Staff Report & Recommendation

Historic Preservation Board

HPB17-0131, 1427 Washington Avenue.

The applicant, Guimel Kodesh, LLC, is requesting a Certificate of Appropriateness for the substantial demolition and partial reconstruction of the existing 1-story Contributing structure including the restoration of the Washington

Original elevation plan, Building Permit No. 1480

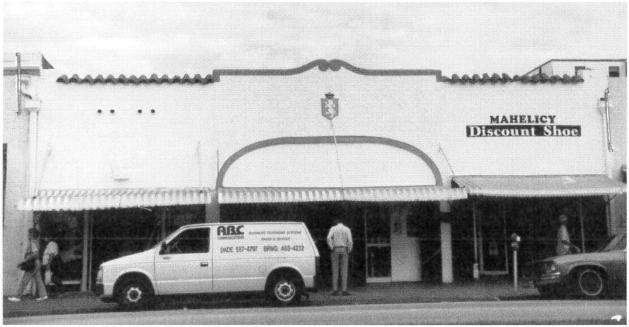
The subject structure was constructed in 1925 and designed in the Mediterranean Revival style of architecture. The name of the architect is not listed on the building card however, after examination of the title block on the original permit drawings, the architect appears to be William P. Shappell. The upper façade of the existing building bears little resemblance to the original

permit plans which depict a raised tower at the northern end of the building and tiled parapet along the remainder.

architectural features located on the primary façade are proposed to be retained. Further, the applicant is proposing to restore the lower façade in a manner substantially consistent with the original permit plans including the reintroduction of the kneewalls and arched transoms, while the upper façade is proposed to be restored as it currently exists. Additionally, the applicant is proposing to reconstruct the roof of the 1-story building approximately 3'-0" taller than the existing roof structure. Staff has no objection to this request as the new roof located within the first approximately 10'-0" of the Washington Avenue façade will be located below the existing parapet. Staff would note that as a part of the building permit process, the applicant will be required to submit shoring plans and sections demonstrating how the facade will be maintained during the course of demolition and construction.
